# UNITED STATES PATENT AND TRADEMARK OFFICE

### Office Action Summary

10/520,092

MARTIN, PETER JOSEF

### Figure 1 of Niske

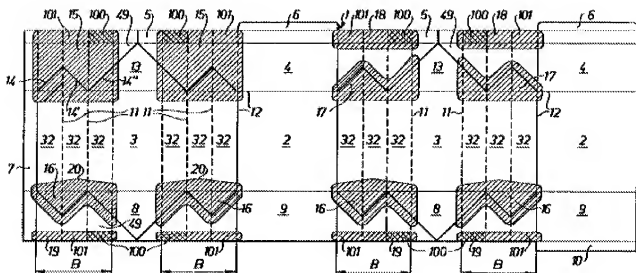
In reference to claim 19, 20, 22, 24-26, 28-30, Niske discloses a packaging material that is folded into a packaging and subsequently filled(column 1 lines 5-14 and 61-65), the packaging material comprising: longitudinal and transverse 12 fold lines; and stamped straight line markings 11, 14, 14', 14'' having intersecting paths, the markings 11, 14, 14', 14'' comprising a parallelogram (32 x1) within a first rectangular frame (32 x2) that has sides that are parallel to the longitudinal fold lines, and the first rectangular frame within a second rectangular frame (32 x3), such that a corner of the parallelogram (32 x1) bisects<sup>1</sup> a side of the second rectangular frame (32 x3);wherein the markings 11, 14, 14', 14'' have a "U-shaped" cross-section. Page 5,

lines 26-37 of Applicant's specification defines the phrase "U-shaped cross-section" as a configuration that projects into or out of a respective surface. Column 5 lines 21-27 of Niske disclose the markings 11, 14, 14', 14" as indentations, thereby meeting Applicant's limitation of markings having a "U-shaped cross-section."
